Access Compliance Report Public Rights-of-Way (Curb Ramps)

Intersection ID: 52112 Main Street: YOUNGBLOOD_ST Cross Street: POINDEXTER_DR Location: E

ADA ID: 288D97569F31 Ramp Type: Perp Initial Pass/Fail: Fail Overall Compliance: No Severity Score: 22.5

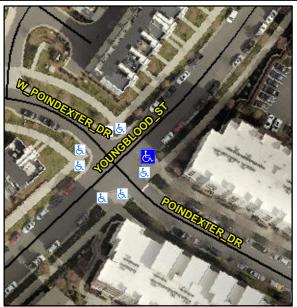
Field Measurements/Component Compliance						
Compliance Description		Data	Comp	liance Description	Data	
N/A	Ramp Length (in)	75.0	No	Ramp Slope (%)	9.1	
No	Ramp Width (in)	47.0	No	Ramp XSlope (%)	2.6	
N/A	Flare Type LT	N/A	N/A	Flare Type RT	N/A	
N/A	Flare Slope LT (%)	N/A	N/A	Flare Slope RT (%)	N/A	
N/A	Flare Traversable LT?	N/A	N/A	Flare Traversable RT?	N/A	
N/A	Landing Length (in)	N/A	N/A	DWS Provided?	N/A	
N/A	Landing Width (in)	N/A	N/A	DWS Contrast?	N/A	
N/A	Landing Slope (%)	N/A	N/A	DWS Length (in)	N/A	
N/A	Landing X Slope (%)	N/A	N/A	DWS Full Width?	N/A	
N/A	Landing Curb? (Y/N)	N/A	N/A	DWS Offset (in)	N/A	
N/A	Shared Landing?	N/A				
N/A	Gutter Ponding?	N/A	N/A	Gutter Slope (%)	N/A	
N/A	Gutter Lip Ht (in)	N/A	N/A	Gutter X Slope (%)	N/A	
N/A	Painted X Walk1?	No	N/A	Painted X Walk2?	N/A	
	X Walk 1 Direction	To NW		X Walk 2 Direction	N/A	
N/A	X Walk 1 Width (in)	N/A	N/A	X Walk 2 Width (in)	N/A	
	X Walk 1 Slope (%)	1.6		X Walk 2 Slope (%)	N/A

Fossible Solution						
Possible Solutions:						
Remove & Replace Entire Ramp.						
Surveyor Notes:						
N/A						
PROW/ADA:						
Not Found, R304.5.1, R304.2.2, R304.5.3						
1100-11010
